Bid 646 New HVAC Modernization Project for Hueneme High School

BID CLARIFICATION ADDENDUM #3

Dated: February 25, 2021

Electrical Narrative (DWG_V2 versus DSA approved drawings)

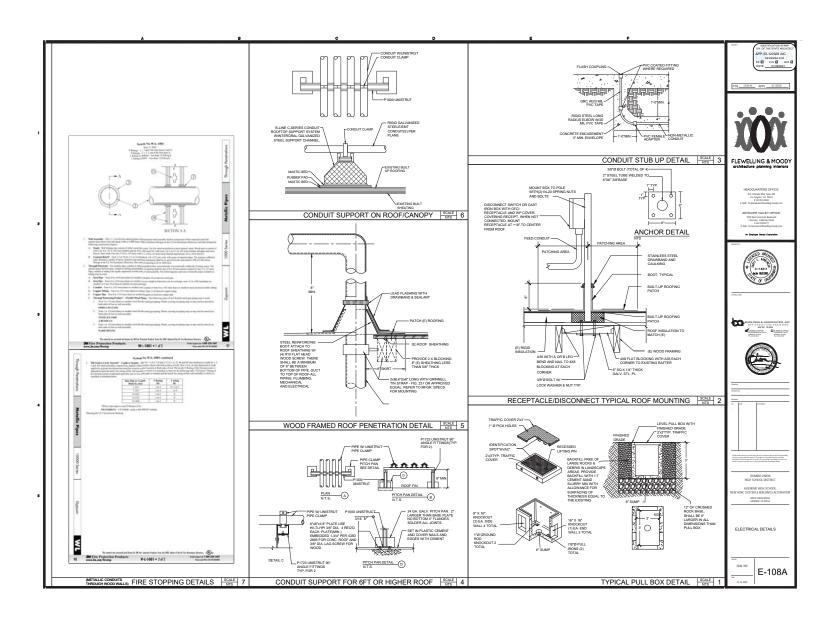
- 1. **E-101:** Selected Option 1 on the MEP Anchorage Note.
- 2. **E-106A**: Called out all lock-on devices for Breakers feeding fire alarm to be painted red.
- 3. **E-106B**: Called out all lock-on devices for Breakers feeding fire alarm to be painted red.
- 4. **E-106C:** Called out all lock-on devices for Breakers feeding fire alarm to be painted red.
- 5. **E-106D**: Called out all lock-on devices for Breakers feeding fire alarm to be painted red.
- 6. **E-108A**: Revised detail 2.
